SERVICE BULLETIN

PRODUCT: GRAIN VAC

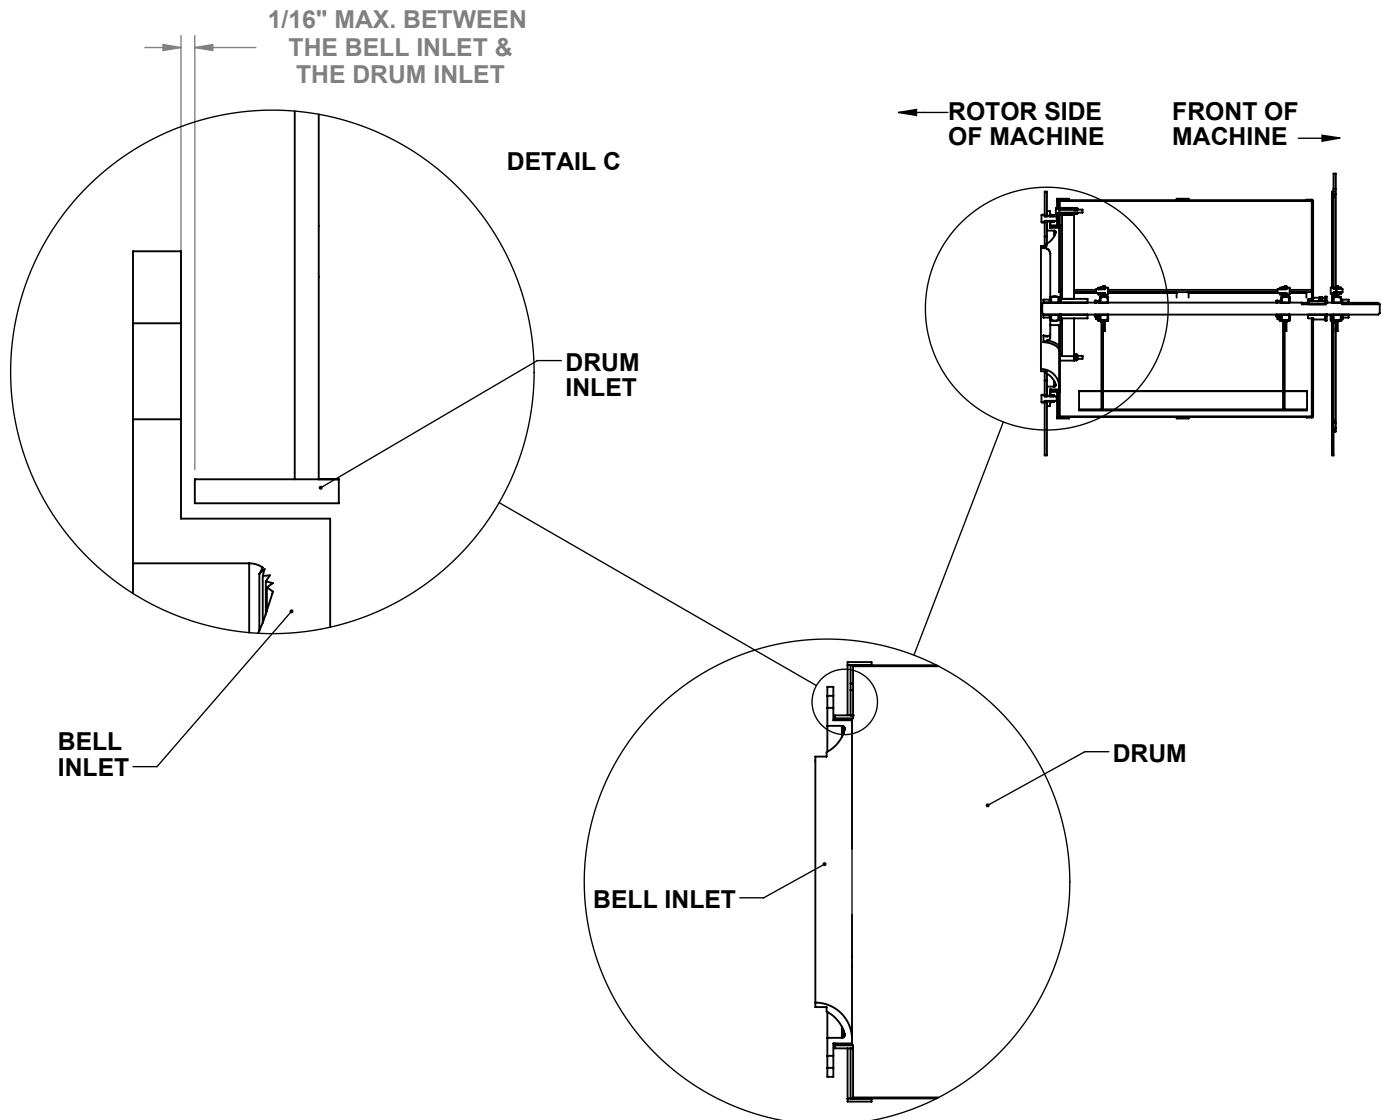
1. INSPECT THE DRUM WELDMENT INLET RING TO SEE IF THERE IS A GAP. IT MUST BE WELDED TO CLOSE THE GAP; AND THEN GRIND INSIDE OF THE DRUM INLET LIP TO ENSURE IT DOES NOT HIT THE OVERLAPPING CAST INLET.

DETAIL D
SCALE 1 : 3

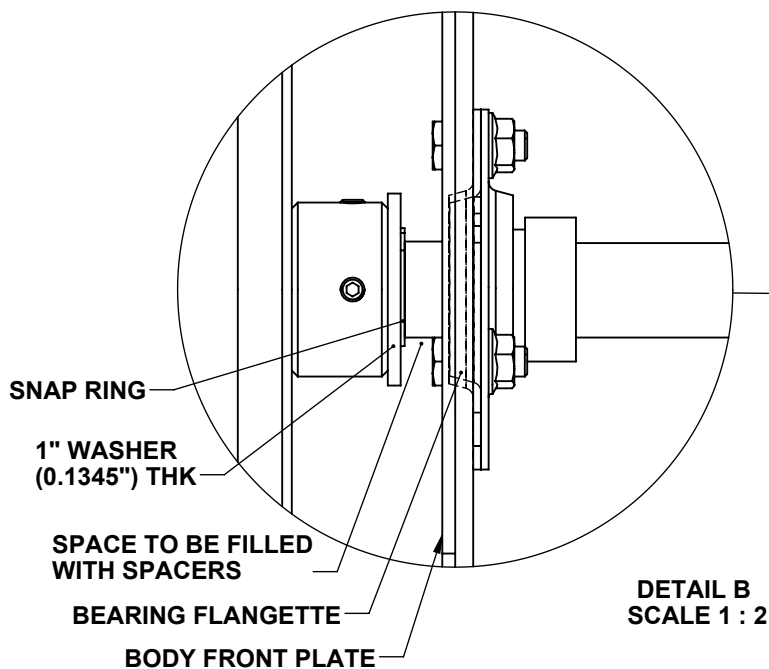
3. IF THE DRUM BOTTOMS OUT BEFORE YOU ARE ABLE TO ATTAIN THIS SPACE, INSERT WASHERS ON THE BOLTS HOLDING THE DRUM CENTER WELD TO THE DRUM (SEE DETAIL "D") TO ALLOW MORE SPACE FOR YOU TO MOVE THE DRUM CLOSER TO THE CAST INLET.

4. ON THE OTHER SIDE OF THE DRUM (SEE DETAIL "B"), THE 5/32" SPACE BETWEEN THE SNAP RING AND THE DRUM HUB SHOULD BE FILLED BY A 1" SAE WASHER (0.1345" THICK, OR MAKE UP WITH STACKING THINNER WASHERS), ONCE THE DISTANCE IS SET THE HUB SET SCREWS SHOULD BE TIGHTENED USING BLUE LOCKTITE AND TORQUEING THEM TO 69 INCH LBS. THE SPACE LEFT BETWEEN THE SNAP RING & THE FLANGETTE OF THE BEARING MOUNTED IN THE FRONT PLATE OF THE VAC SHOULD BE FILLED BY SPACERS/WASHERS SO THE DRUM CANNOT BECOME LOOSE AND MOVE AWAY FROM THE CAST INLET.

Figure 1

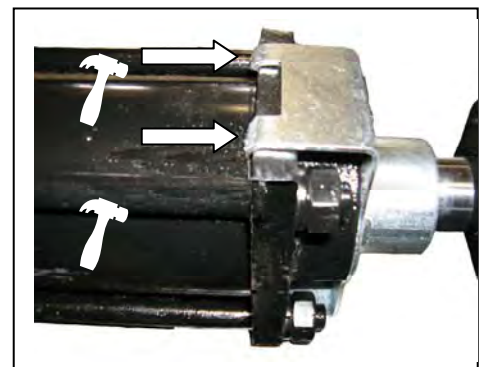
1. Detach the top cylinder linkage pin from the top auger tube.
2. Remove the clevis from the cylinder shaft.
3. Fit the cylinder spacer over the shaft as shown in figure 1.
4. Carefully bend the tabs over the end of the cylinder as shown in figure1.

DRIVE DOG 5/16" BOLT RETROFIT INSTRUCTIONS

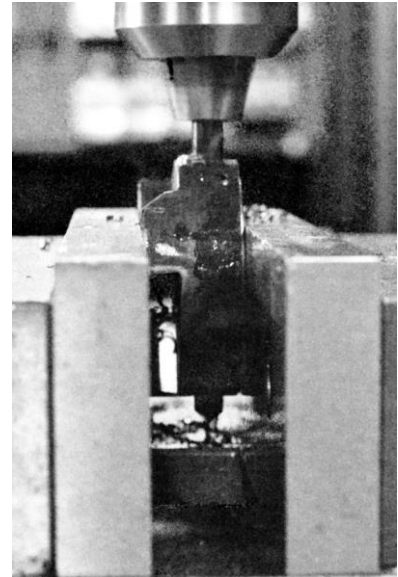
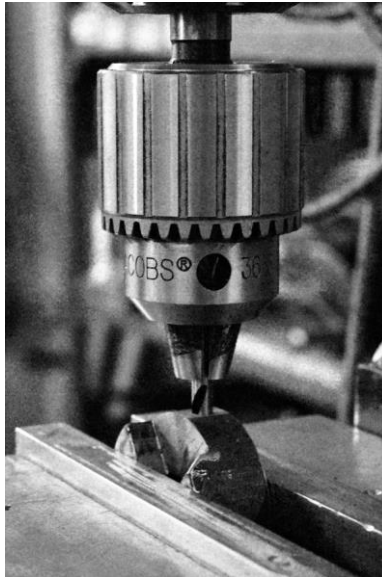
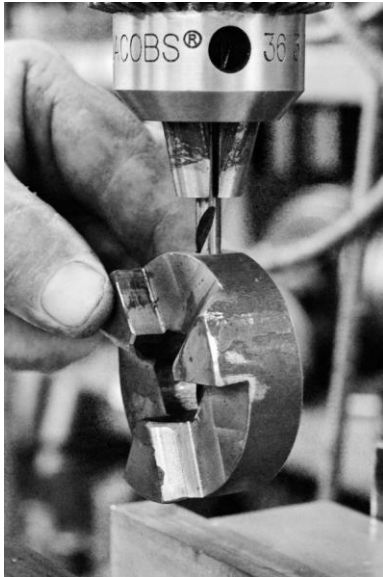
3. Drill out the drive dogs to 21/64" using a drill press. To ensure the hole in the drive dog aligned with the drill bit:

- a. Place a 17/64" bit in the chuck and slide the drive dog onto the drill bit.
- b. Lower the spindle, align the vise, and clamp the drive dog. Raise and lower the spindle and check that the 17/64" bit passes through the drive dog without deflecting. Check that there is enough clearance for a 21/64" drill bit. Readjust positioning if necessary. Once aligned do not move the vise.
- c. Replace the 17/64" drill bit with a 21/64" drill bit and drill through the drive dog.
4. Place the drive dog backs onto the hex shafts and line up the holes.
5. Drill through the hex shaft with a 21/64" drill bit using the drive dog holes as a guide.

6. Remove the drive dogs from the hex shafts and reinstall the flying.
7. Fasten the drive dog back onto the shaft with the new 5/16" hardware provided.

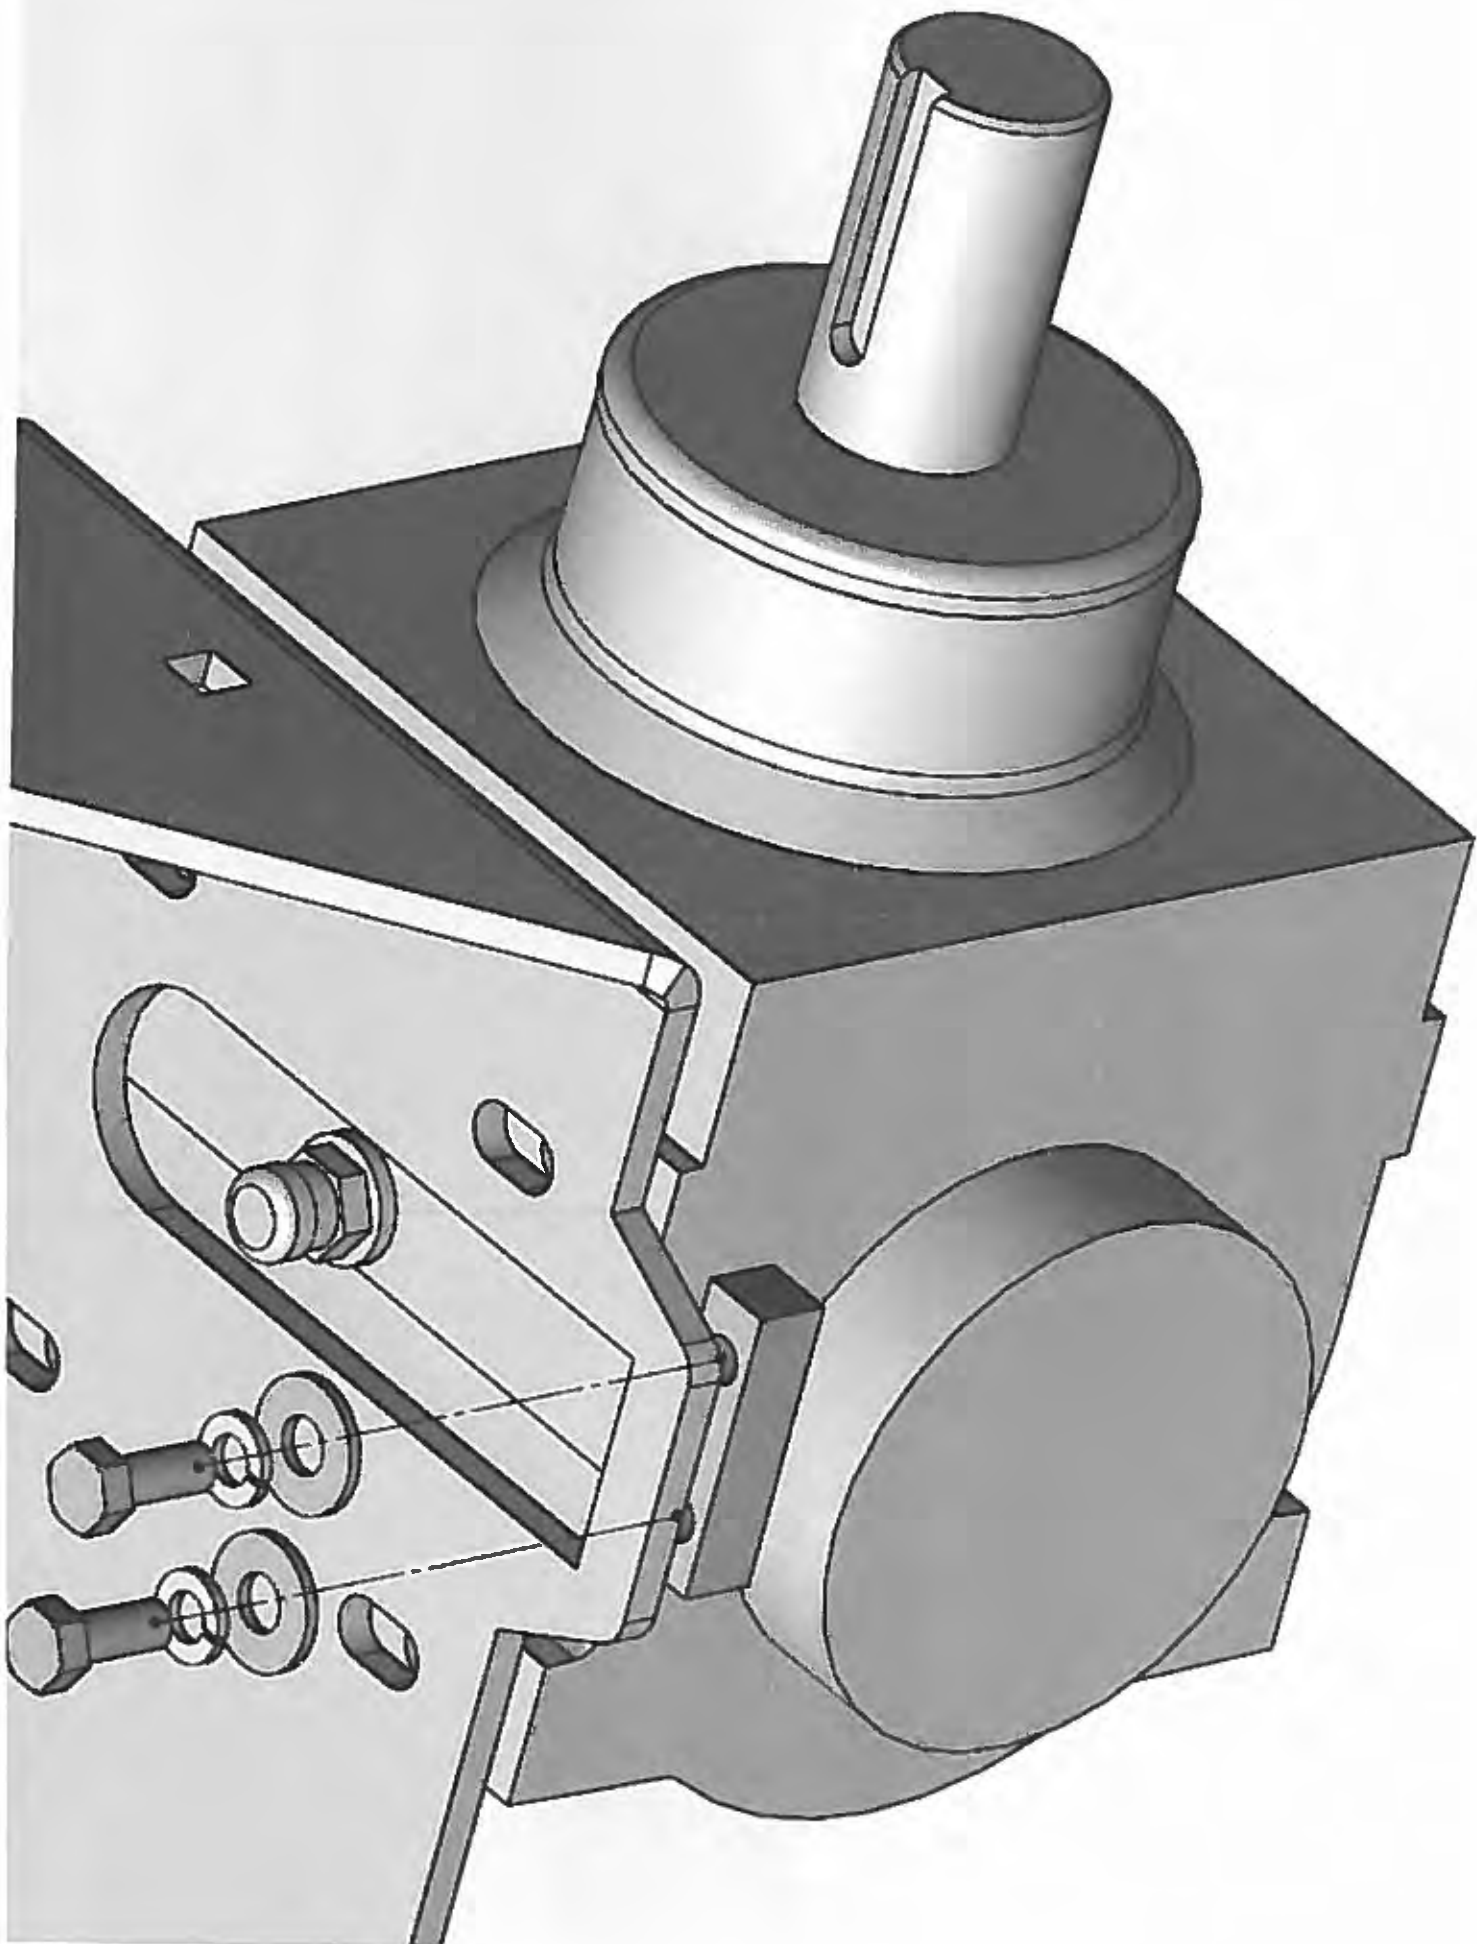
The gearbox on the VR12 may slide down on the mount bolts if they are not completely tight. When this happens, the drive dogs move away from each other causing them to disengage or slip.

We have designed a gearbox stopper kit to aid in holding the gearbox up in place so it cannot slide down.

Please install the stopper kit as shown in the attached drawing.

Figure 1: Air Breather and Oil Level Check Plugs

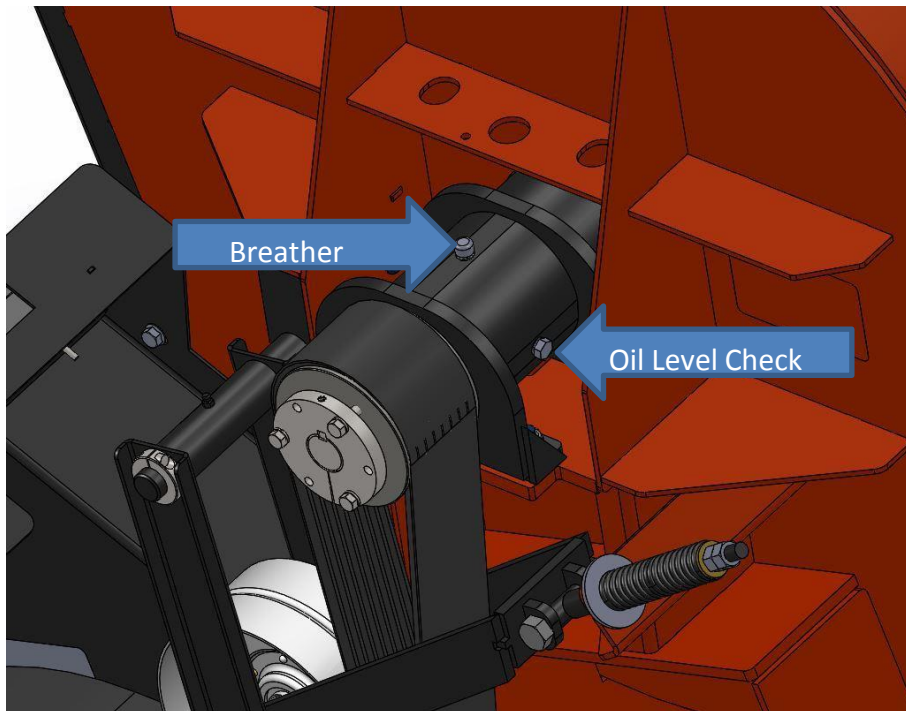
- The rotor bearing cartridge requires SAE 75W90 synthetic gear oil for top-up (if needed).
 1. Place the VR12 on a flat, even surface that will help ensure that the unit is as level as possible.
 2. Remove the hoses from the hose racks.
 3. Remove the rear upper guard to gain access to the bearing cartridge.
 4. Remove the oil level check plug on the side of the bearing cartridge.

1. Remove the air breather plug (see Figure 1).
2. Wash the plug with solvent.
3. Blow compressed air through the air breather plug passage to ensure that it is open.
4. Reinstall and tighten the air breather plug.

Figure 2: Correct Rotor Bearing Cartridge Oil Level

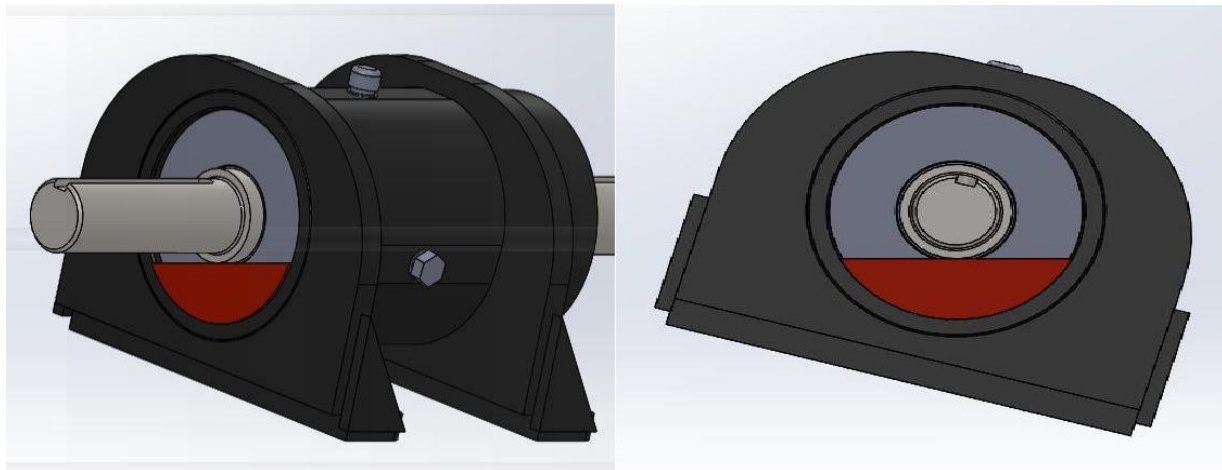
5. The oil level should come up to the lower edge of the oil level hole. If necessary, add oil through the breather plug hole (use SAE 75W90 synthetic gear oil) until the correct oil level is reached.

NOTE: The oil level check plug measures the correct oil level while the bearing cartridge is installed, at its installed angle (see Figure 2 below).
